I am opposed to the Liverpool Range (LR) wind farm 'Modification'. I have many concerns listed below.

Figure 1 – Overlap of the LR Modification Project with the Regent Honeyeater Priority Area 2

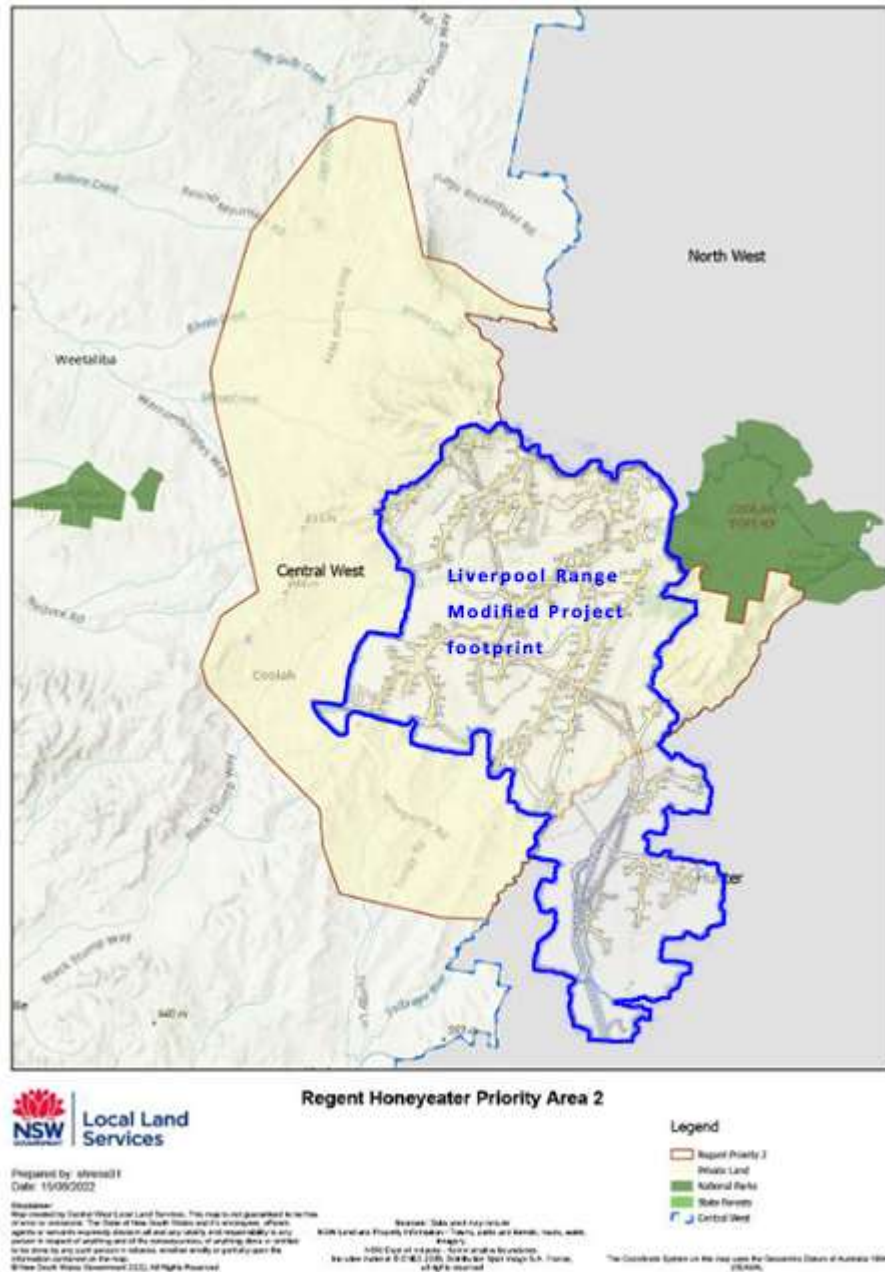
The central problem with the LR project regarding its environmental impacts, such as the destruction of NSW Box-Gum Woodland CEEC, relates to its vast scale. Much of its planned 50,000+ ha footprint covers the uncommon basalt soil environment that is essential for the NSW Box-Gum Woodland CEEC. Figure 1 shows one consequential issue arising from the extensive overlap of the modified LR project with the Regent Honeyeater Priority Area 2. Presumably there is a lack of communication between various government departments, otherwise the overlap area would have already been removed from the proposed development footprint. Tilt also quantifies some of their planned environmental destruction:

In addition, the Modified Project is anticipated to have the following impacts to relevant Matters of National Environmental Significance (MNES) listed under the EPBC Act: - 577.8 ha of potentially suitable habitat for the regent honeyeater (threatened species) - 471.7 ha of potentially suitable habitat for the swift parrot (threatened species) - 284.5 ha of potentially suitable habitat for the

large-eared pied bat (threatened species), and - 672.3 ha of potentially suitable habitat for the koala (threatened species) (EIS pg15):

In addition to the extensive destruction of the NSW Box-Gum Woodland CEEC, such a vast area of wind turbines will create a highly hostile environment for all birdlife across the 50,000 ha footprint. This development will put extensive pressure on fauna such as predatory birds, bats and other threatened species.
